PRAIRIE ISLAND NUCLEAR GENERATING PLANT
CHANGES TO OFFSITE DOSE CALCULATION MANUAL (ODCM)

REV. 4

DOCKET NO. 50-282 and 50-306

NORTHERN STATES POWER COMPANY
MINNEAPOLIS, MINNESOTA

FIGURE 5.1-1
PRAIRIE ISLAND NUCLEAR GENERATING PLANT
RADIATION ENVIRONMENTAL MONITORING PROGRAM

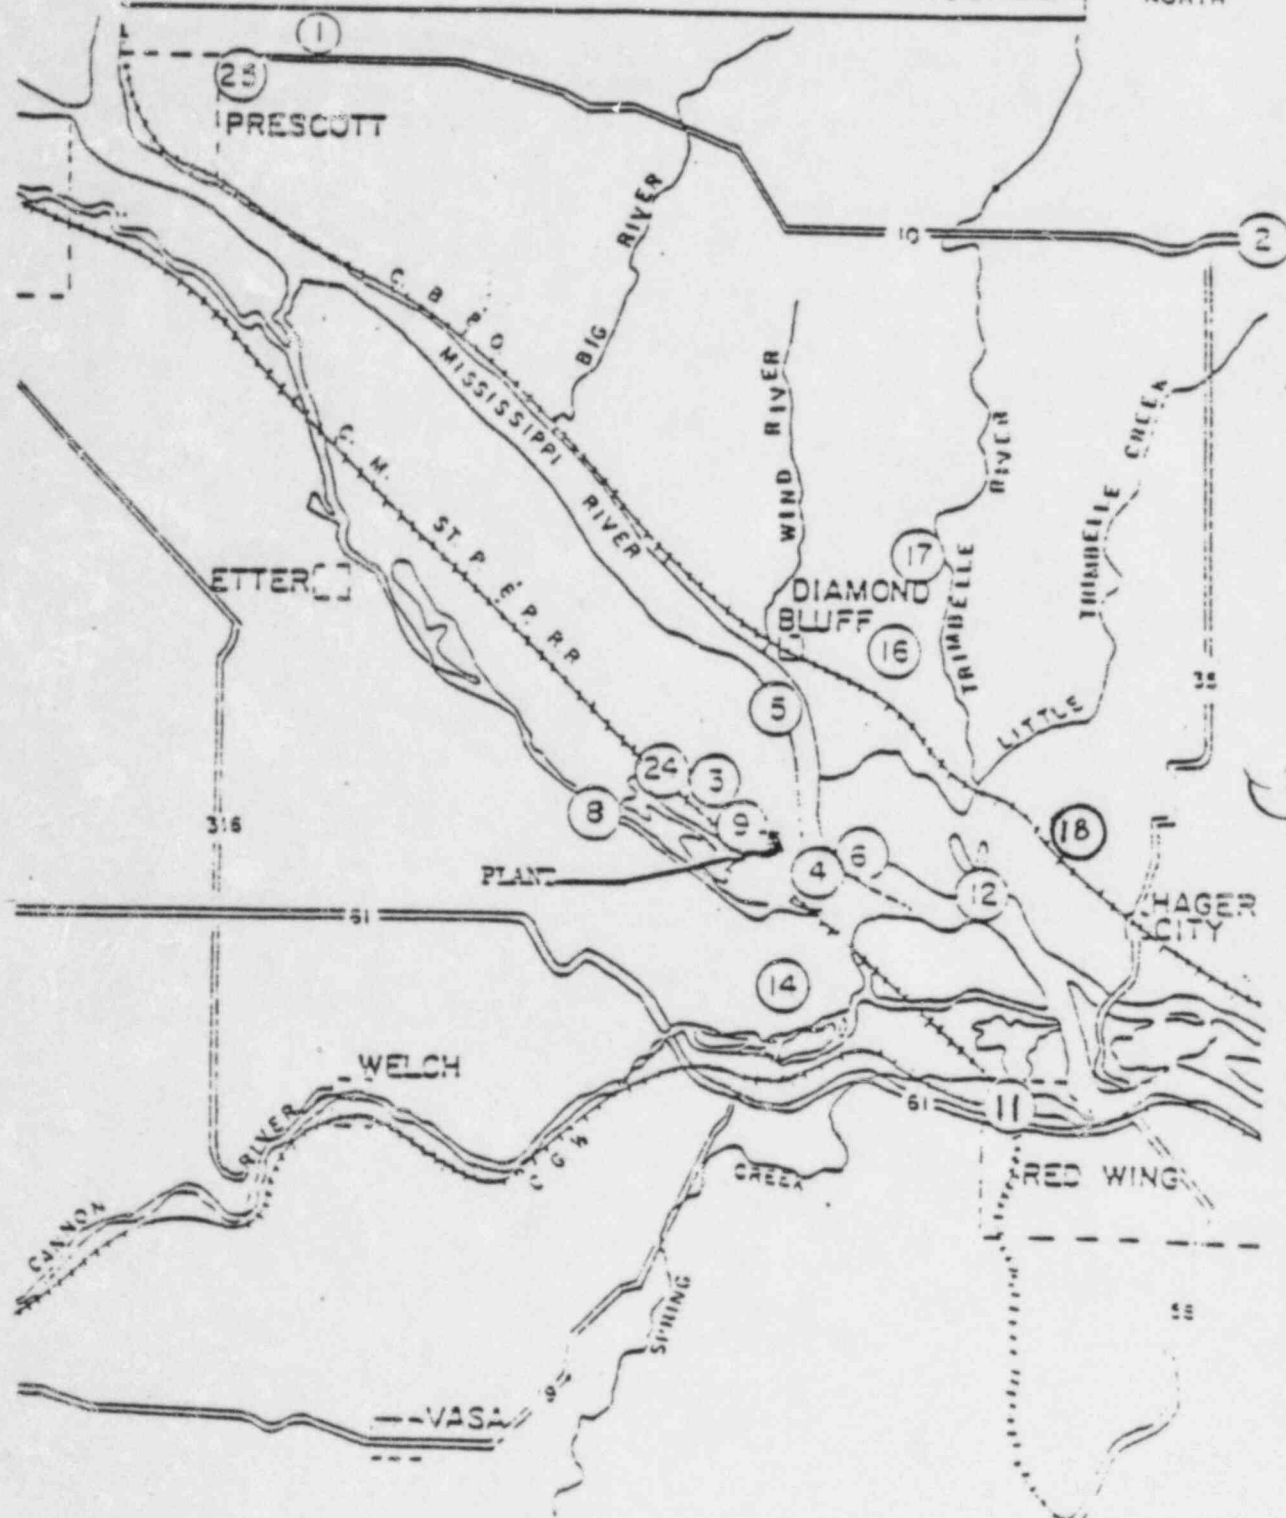
In accordance with the Prairie Island Technical Specifications Section 6.5 E, Offsite Dose Calculation Manual (ODCM), a change to Figure 5.1-1 and Table 5.1-1 Radiation Environmental Monitoring Program, Sampling Location is submitted.

One of three dairy farms required by the sampling program is located 3.5 miles at 181°/S from the facility. The dairy farm owner has decided to move his operation to another location.

After consulting the Dispersion Parameters (D/Q) in the Offsite Dose Calculation Manual, the decision was made to sample raw milk from the Perry Christensen Farm located 3.7 miles at 88°/E of the plant, the next highest D/Q farm.

Milk	P-18	Christensen Farm	3.7 mi @ 88°/E
